PROPOSED CLASS 2 RESOURCE CONSERVATION AND RECOVERY ACT (RCRA)
 PERMIT MODIFICATIONS AND REQUEST FOR TEMPORARY AUTHORIZATION AT
 THE 183-H SOLAR EVAPORATION UNIT (TSD: T-1-4)

Class 2 modification to the Hanford Facility Dangerous Waste Permit, Revision 8C and a red line strike out of Chapter 3.0, Groundwater Monitoring for the 183-H Solar Evaporation Unit pursuant to WAC 173-303-830(4)(b)

**Part VI, Closure Unit 2
183-H Solar Evaporation Basins**

9 **Figure 3.1. Location Map for 100-H Area Monitoring Wells**

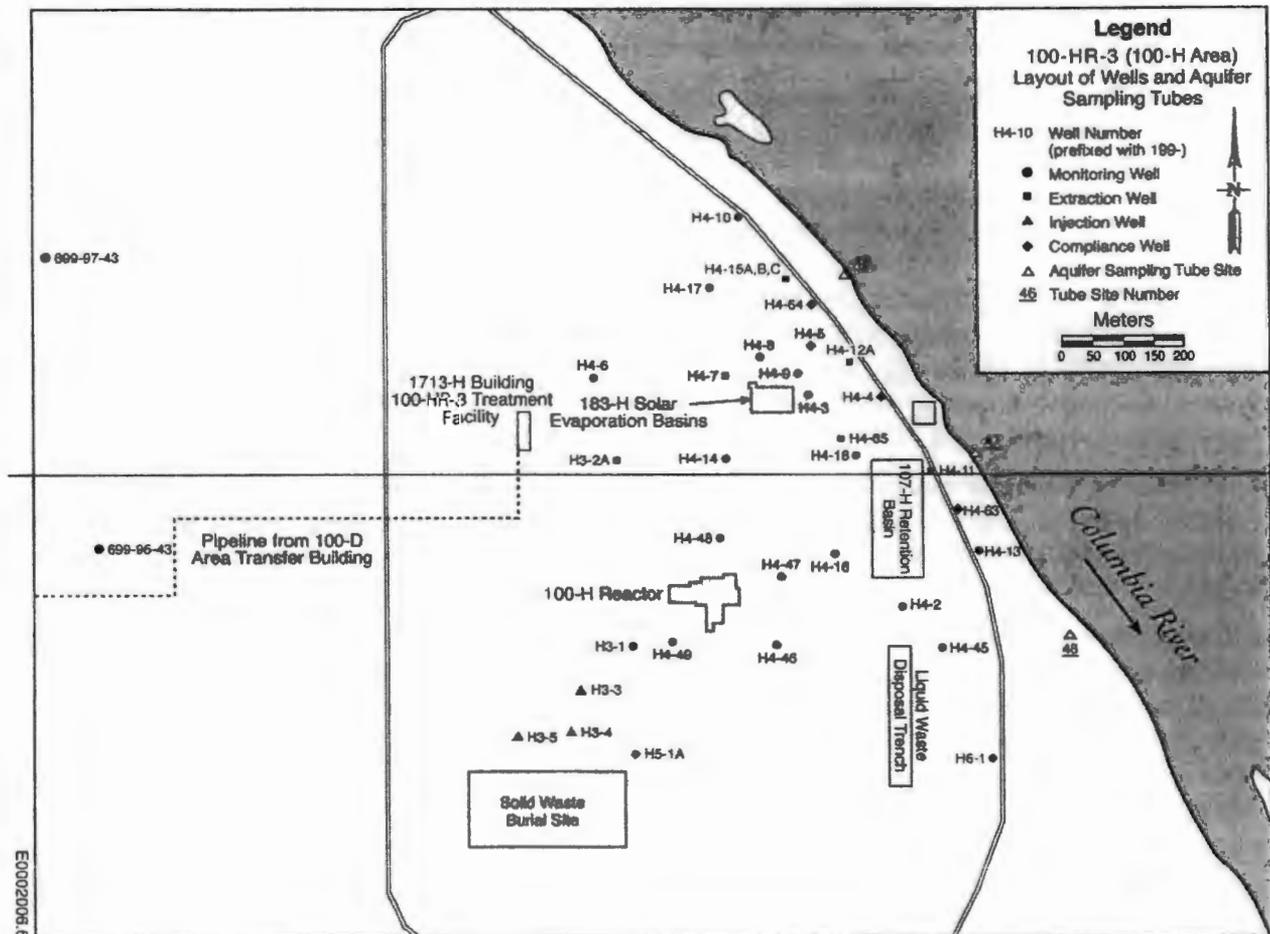
1 The RCRA sampling and analysis schedule includes a network of four wells sampled annually. The wells
2 are 199-H4-3, 199-H4-8, 199-H4-12A, and 199-H4-12C, and 199-H4-84 (Figure 3.1). (Wells 199-H4-8
3 and 199-H4-12A/12C is-are also used as an extraction wells for the pump-and-treat system.)
4 (~~Wells 199-H4-8 and 199-H4-12A are also used as extraction wells for the pump-and-treat system.~~) Water
5 samples will be analyzed for the constituents of concern previously identified for tracking contamination
6 attributable to the 183-H Solar Evaporation Basins (nitrate, fluoride, chromium, uranium, and
7 technetium-99). Additional analyses will be performed for alkalinity, other anions, and other metals, to aid
8 in interpreting results. Field parameters (pH, temperature, specific conductance, and turbidity) will also be
9 measured.

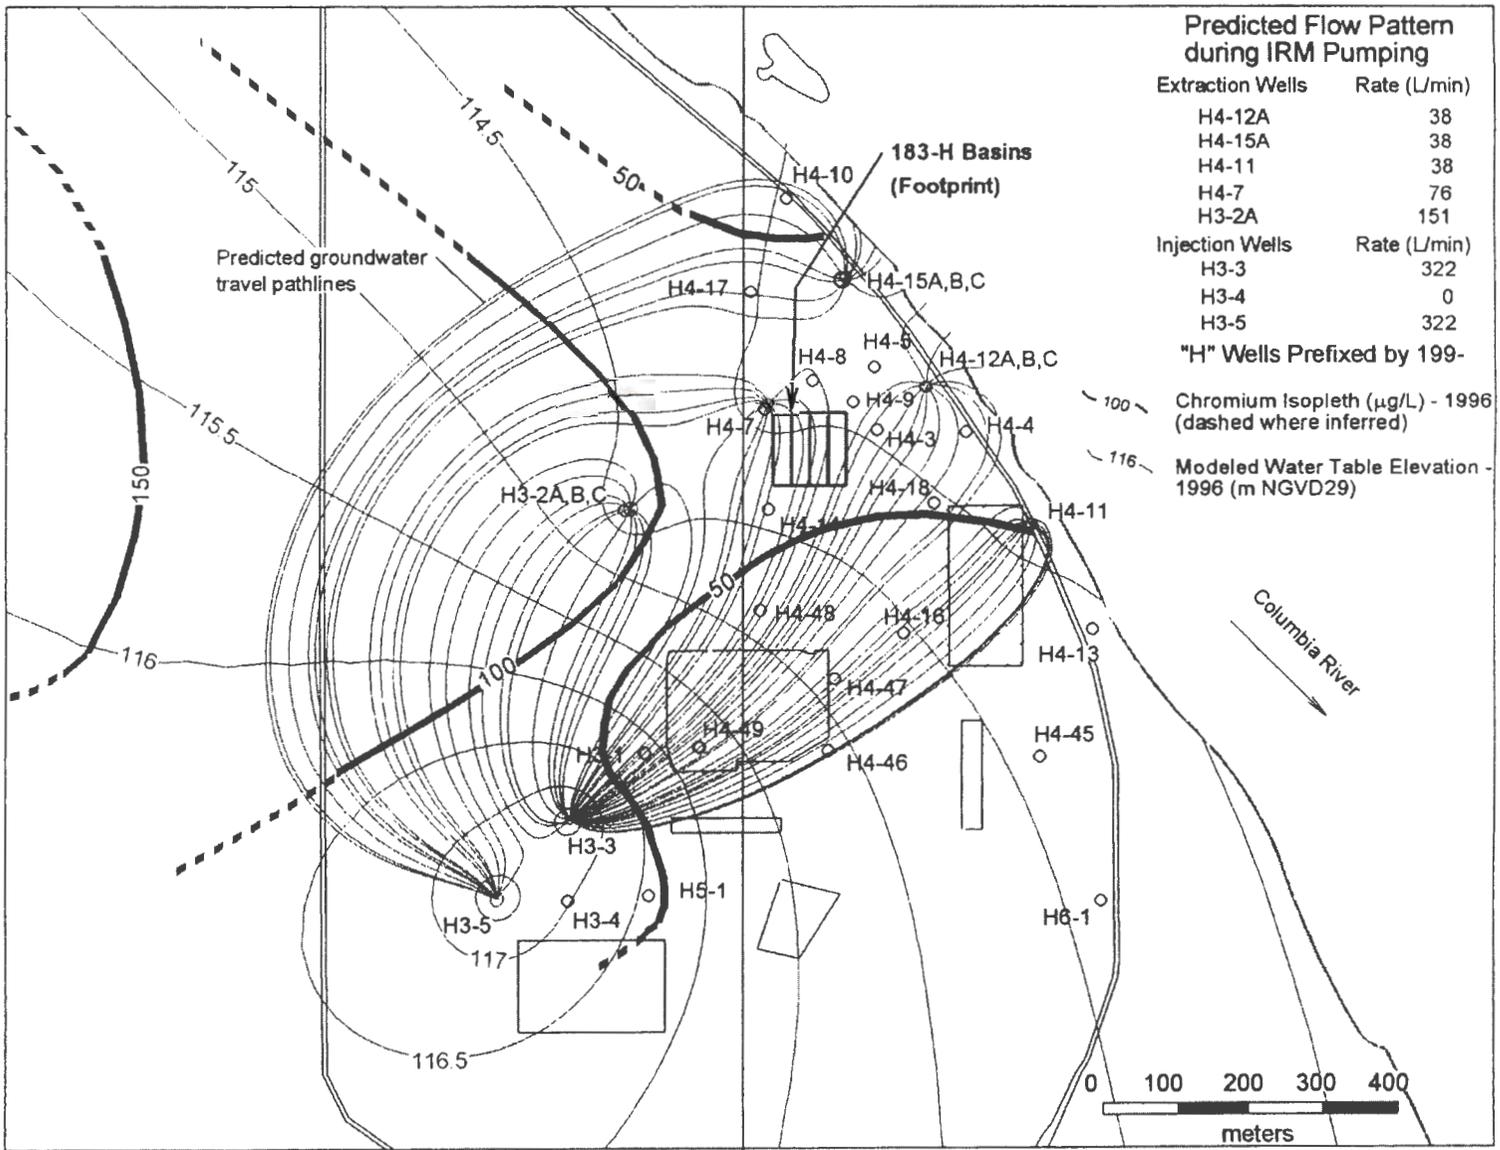
Hanford Facility RCRA Permit Modification Notification Form					
Unit: 183-H Solar Evaporation Basins		Permit Part Part VI, Post Closure Unit 2			
<p><u>Description of Modification:</u> Chapter 3.0, Figure 3.2:</p> <p style="text-align: center;">Figure 3.2. Location Map for 100-H Area Monitoring Wells</p> <p>Changes to this figure have been made to maintain consistency with Section 3.2</p>					
WAC 173-303-830 Modification Class ^{1 2}		Class 1	Class '1	Class 2	Class 3
Please mark the Modification Class:				X	
<p>Enter relevant WAC 173-303-830, Appendix I Modification citation number: C.1.a</p> <p>Enter wording of WAC 173-303-830, Appendix I Modification citation:</p> <p>Changes in the number, location, depth, or design of upgradient or downgradient wells of permitted groundwater monitoring system. Removal of well 199-H4-3 from the RCRA groundwater monitoring network and replacement with 199-H4-84 reflects changes made during 2011 remedial investigation activities. Well 199-H4-3 needs to be decommissioned, because it interferes with the 100H Area waste sites excavation footprint. Well 199-H4-84 is closer to the waste site and should better represent groundwater conditions. The CERCLA pump & treat system is connected to 199-H4-12C, not 199-H4-12A. Well 199-H4-12A is completed in the unconfined aquifer, where hexavalent chromium concentrations are low. Well 199-H4-12C is completed in the confined aquifer within Ringold Upper Mud unit, where hexavalent chromium concentrations were found to be above 100 ppb. Well H4-7 is being removed from the figure to reflect its scheduled decommissioning from the CERCLA interim action network to support vadose zone remediation activities in the 100-H Area. The figure is also being updated to current DOE and CHPRC cartographic standards (river arrows, color changes, legend changes, etc.). Changes to the figure reflect the operation of the new HX pump and treat system and revisions to the CERCLA and RCRA monitoring networks.</p>
